Responses to NRC Request for Additional Information

Materials License No. STB-401

Mallinckrodt Inc, Docket No. 40-6563

Figure 9-1. C-T Phase II Decommissioning Organization

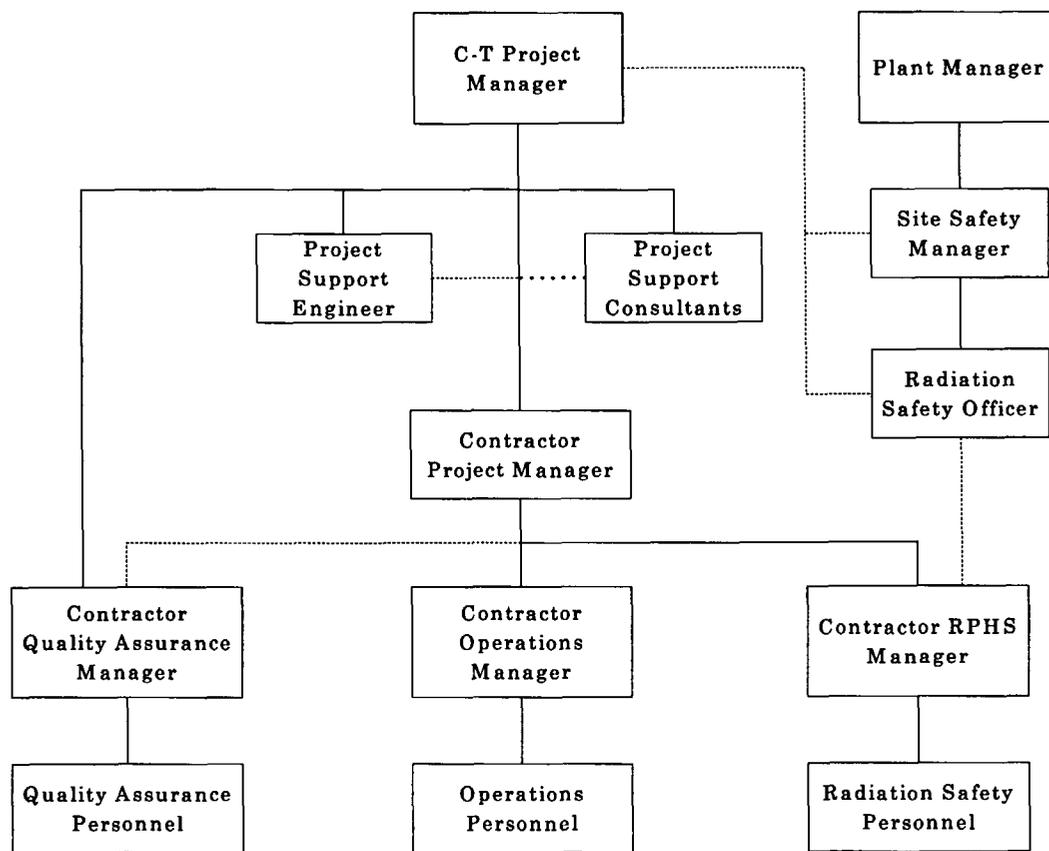
93. 1. Provide clarification of Mallinckrodt's decommissioning organization. Descriptions on page 9-2 and Figure 9-1 are not consistent. Furthermore, there is no "SSRO" on the organization chart in the description. [see page 9-4 of the DP.]

An SSRO, mentioned in DP §9.2.2 on page 9-4, is intended to refer to Mallinckrodt's Radiation Safety Officer, or RSO. DP §9.2.2 is being revised to refer to Mallinckrodt's RSO as one who also reviews and approves procedures addressing radiation safety issues.

CT 2 DP, §9.1.3 and §9.3.2 are being revised to provide information requested in this item and to align with the revised organization chart, Figure 9-1.
